Citizens Committee to Complete the Refuge

June 15, 2022

RE: Notice of Preparation of an Environmental Impact Report for the Strategy to Advance Flood Protection, Ecosystems and Recreation along San Francisco (SAFER) Bay Project

Figure 3 from the NOP shows a levee with an 84-foot base extending from the edge of Hacker Way west into Ravenswood Slough.

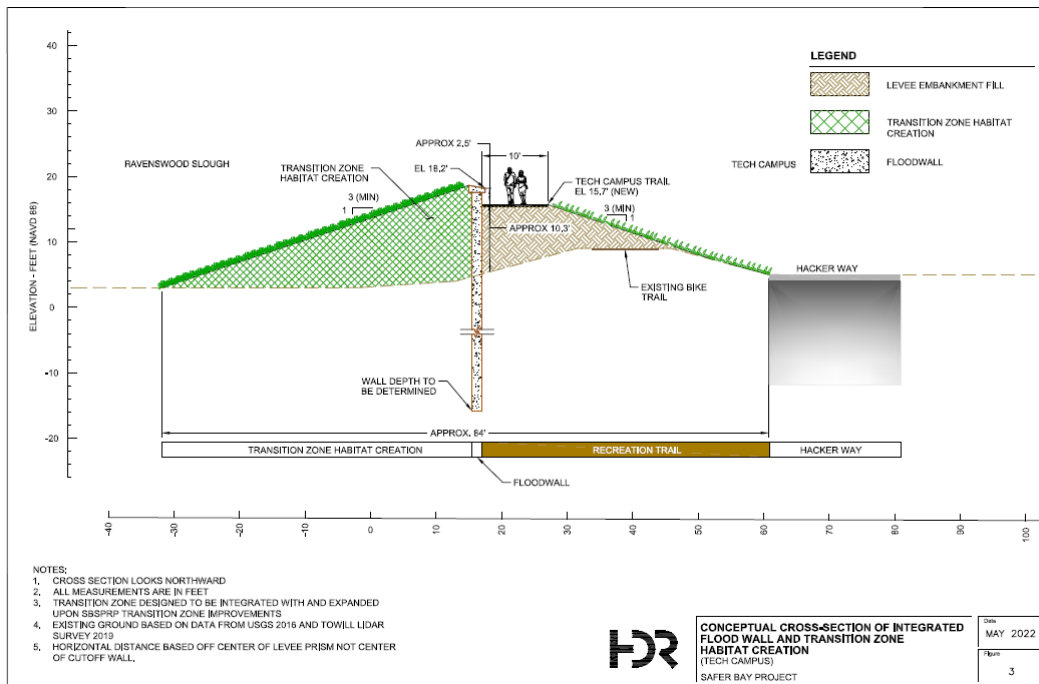
The NOP does not provide information on potential Project impacts to the salt marsh habitat in this section of Ravenswood Slough; however, using the figures provided in the NOP (Figures 1,3 and 4) it is clear that there is a potential for loss of salt marsh along 1.25 miles of Ravenswood Slough from the proposed Project levee.

- ★ For each alternative considered in the EIR for this reach, even at the program level, there must be specific locations and acreage provided for any wetlands and waters that could be temporarily, permanently, directly and indirectly impacted from the Project. The types of impacts and acreages of impacts should be provided in a table – (e.g. temporary, permanent, direct, indirect, habitat type, acreage).

Current conditions showing convergent shorelines (yellow line) of Ravenswood Slough going inland (north to south).

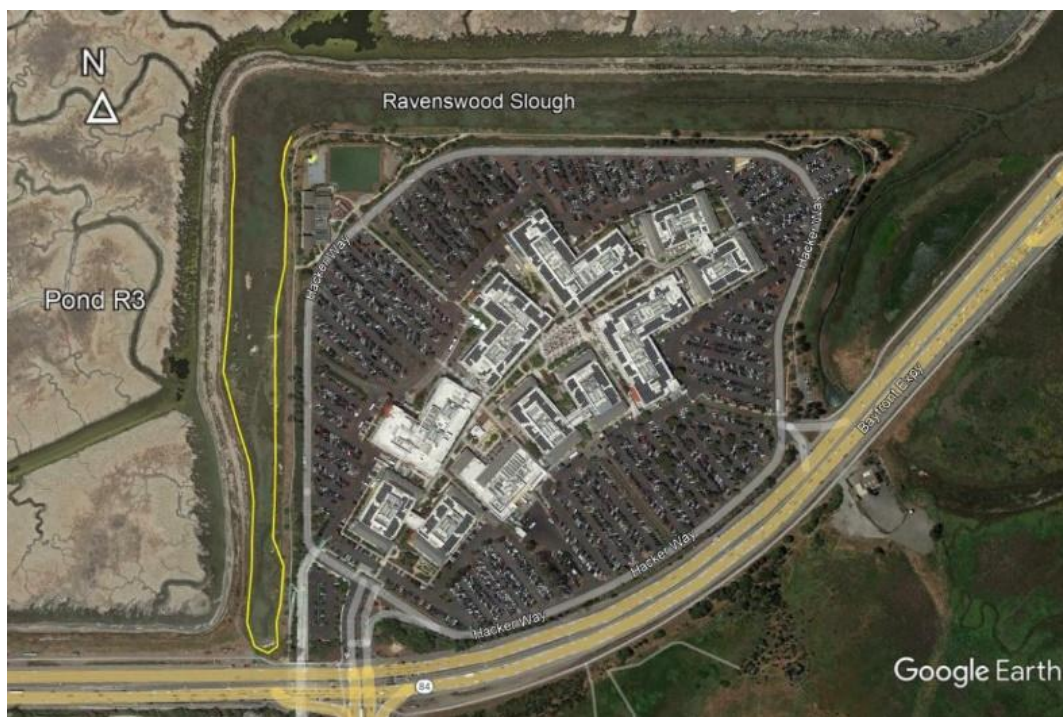
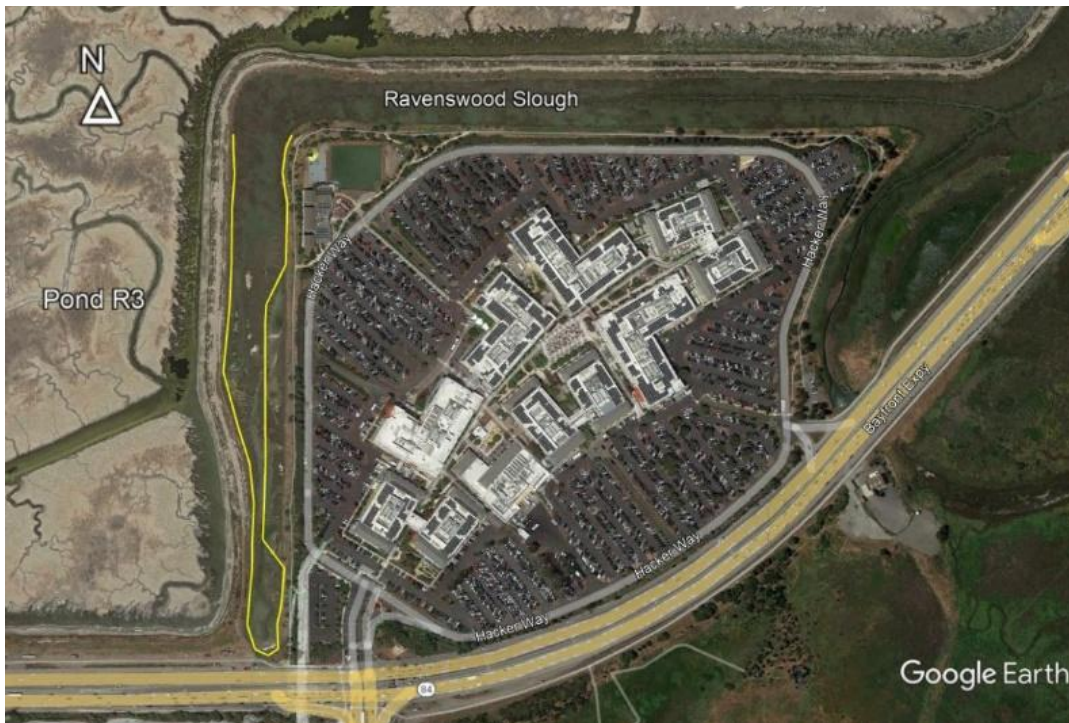
Converging shorelines increase tidal amplitude towards the landward end of enclosed estuaries⁶. Without knowing the extent to which a proposed levee may encroach into Ravenswood Slough, thereby increasing the convergence of the shorelines, it is not possible to determine what impact increased tidal amplitude may have on the structural integrity of the Pond R3 levee across the slough (even without sea level rise) that protects habitat for shorebirds and breeding western snowy plover from inundation.

Ravenswood Slough shoreline with base of 84-foot levee extending west from Hacker Way, showing increased convergence of the shorelines.

Ravenswood Slough shoreline with base of 117-foot levee extending west from Hacker Way, showing increased convergence of the shorelines.

- ★ The EIR should include an analysis of the potential hydrological changes in Ravenswood Slough (including changes in tidal amplitude) from the Tech Campus levee, and how those changes could impact the levee protecting the shorebird habitat in the Refuge's Pond R3.

Figure 16 from the Feasibility Report showing the Option 1 floodwall with a greatly reduced Project footprint. Ravenswood Slough is on the left.

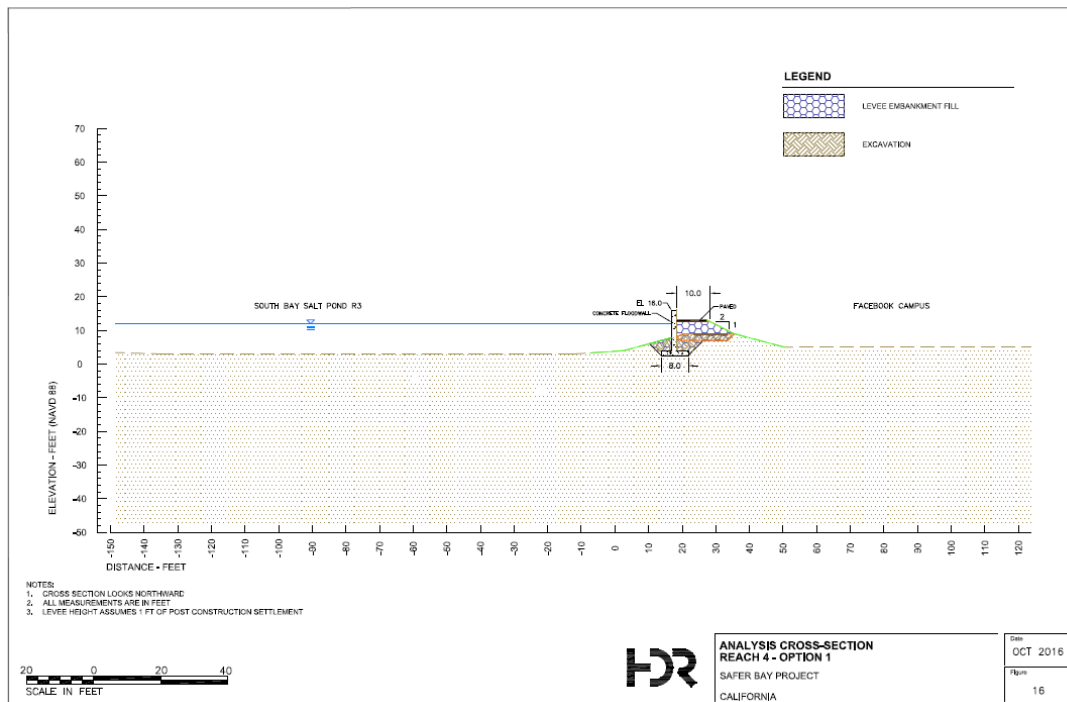
The SBSRP plan for Pond R3, currently being implemented, is to enhance this managed pond for shorebirds and western snowy plover nesting habitat, and not restoration to tidal marsh. This decision was published in the *South Bay Salt Pond Restoration Final Environmental Impact Statement/Report, Phase 2 Executive Summary* in April 2016. On Page 7 of the NOP, there is a statement that the Project would provide habitat enhancement for nesting plovers in Pond R3; however, the NOP included updated figures for this reach (Figures 3 and 4) with the same 2016 Feasibility Report levee designs for possible restoration to tidal marsh. These designs are for a levee with a large footprint and “transition zone habitat” extending well into Ravenswood Slough. There appears to be no reason at this point to have a larger levee with a transition zone surrounding the tech campus.

- ★ In order to avoid or minimize impacts to the Ravenswood Slough wetlands and endangered species, the Project should reconsider the Feasibility Report's Reach 4, Option 1 levee shown in Figure 16 below, or another levee design that eliminates any permanent fill in Ravenswood Slough.
